# FALCON SERVICE ADVISORY

FSA2000-80-00-07-R1

## New Engine Air Starter P/N 3505656-7

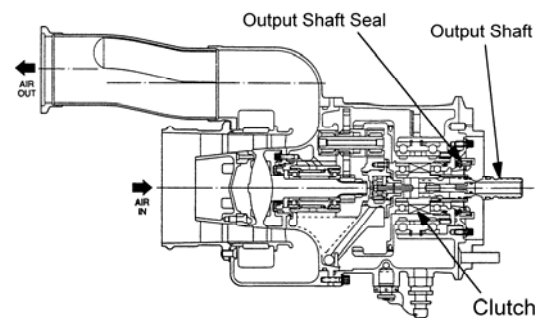
Field feedback shows that occurrences of oil leakage have not been significantly reduced with this air starter version as initially targeted. In addition, several air starters P/N 3505656-6 were removed after no rotation during engine start due a decoupled output shaft.

Evaluation of the returned units revealed that the oil leakage originated from the output shaft carbon seal damaged by heat. This heat was generated from high speed contacting surfaces.

A new air starter P/N **3505656-7** has been developed to improve the output shaft seal and the decoupler design.

The output shaft seal becomes a non-contacting seal eliminating heat generation that the carbon and rotor contacting surfaces produced.

The decoupler has been redesigned to eliminate nuisance decouplings.
